NEW BEDFORD REGIONAL AIRPORT  
RUNWAY 5-23 – PHASE 4

Weekly Environmental Report

**NEW BEDFORD REGIONAL AIRPORT  
RUNWAY 5-23 – PHASE 4  
Reconstruct, Mark and Grove  
Report on RSA 5 – ILS Road / West Ditch silt fence failure**

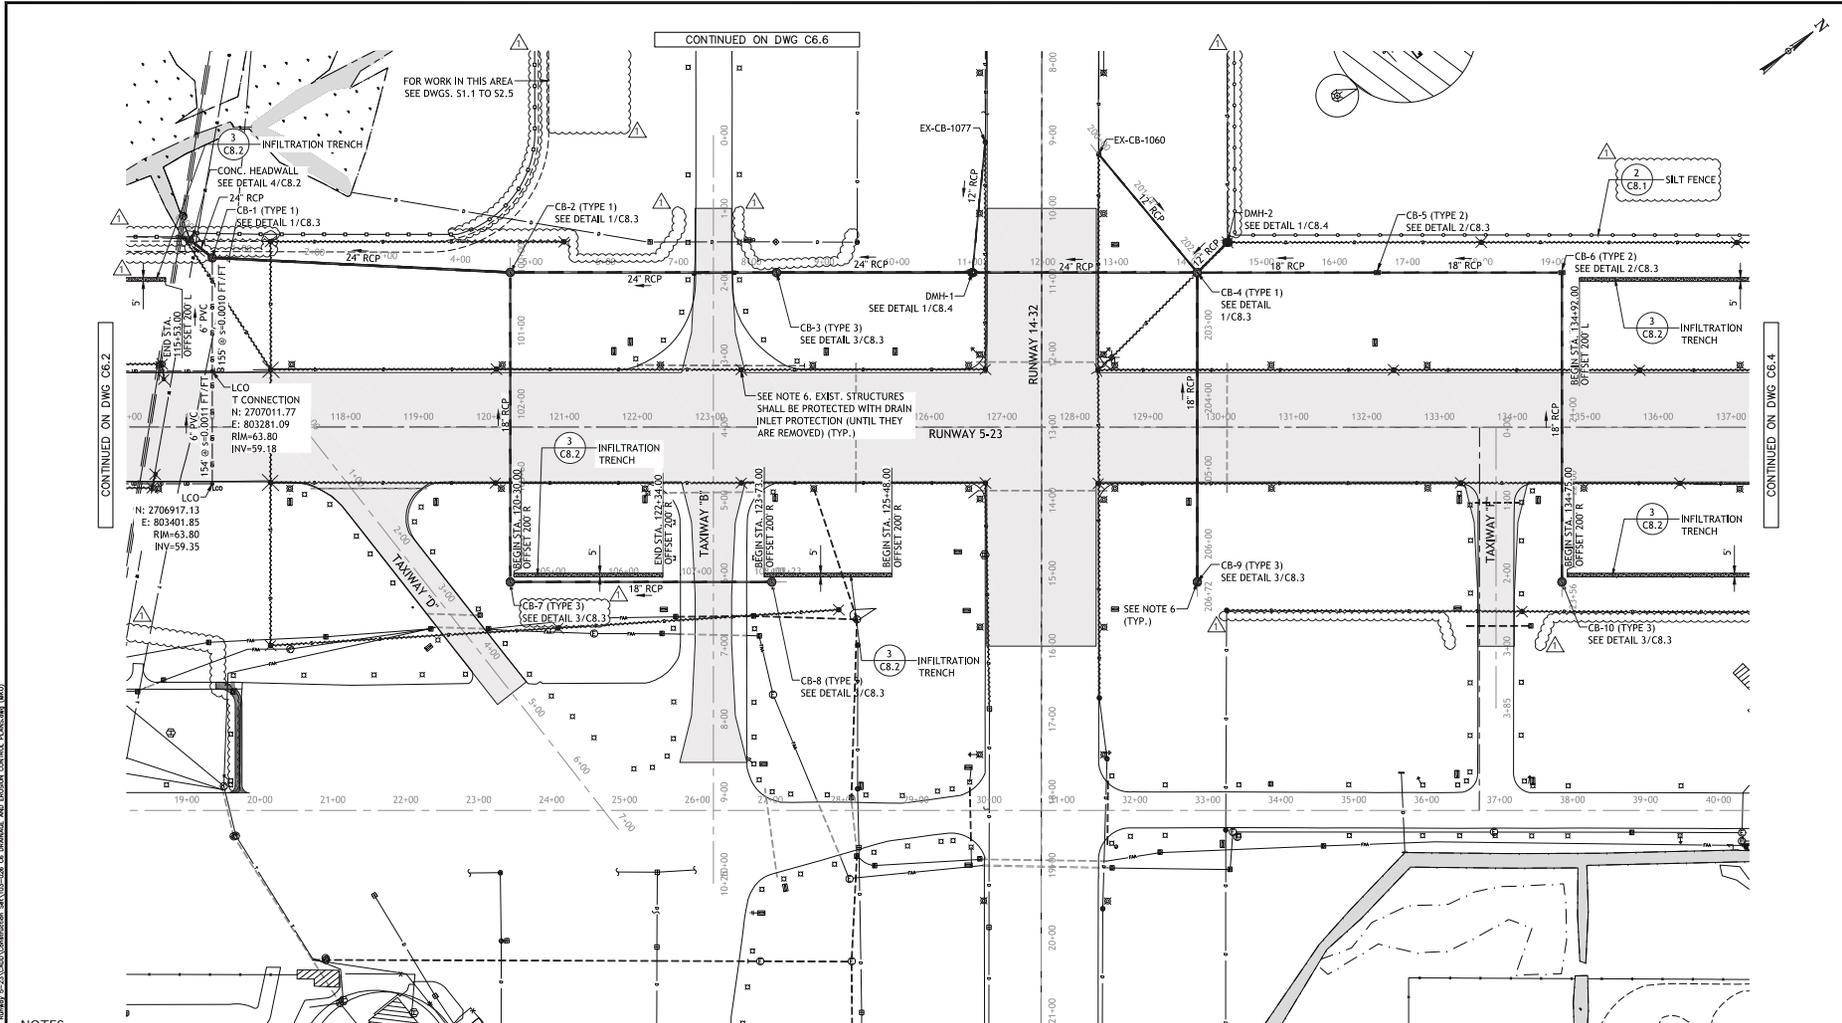
- In conjunction with resident engineer, Ed Clark, revised location of silt fence at bottom of slope so that silt fence does not cross the drainage swale. Added straw wattles across the drainage swale to provide some energy dissipation during higher flows. Will need to add stone to outfall of twin pipe drain in swale.
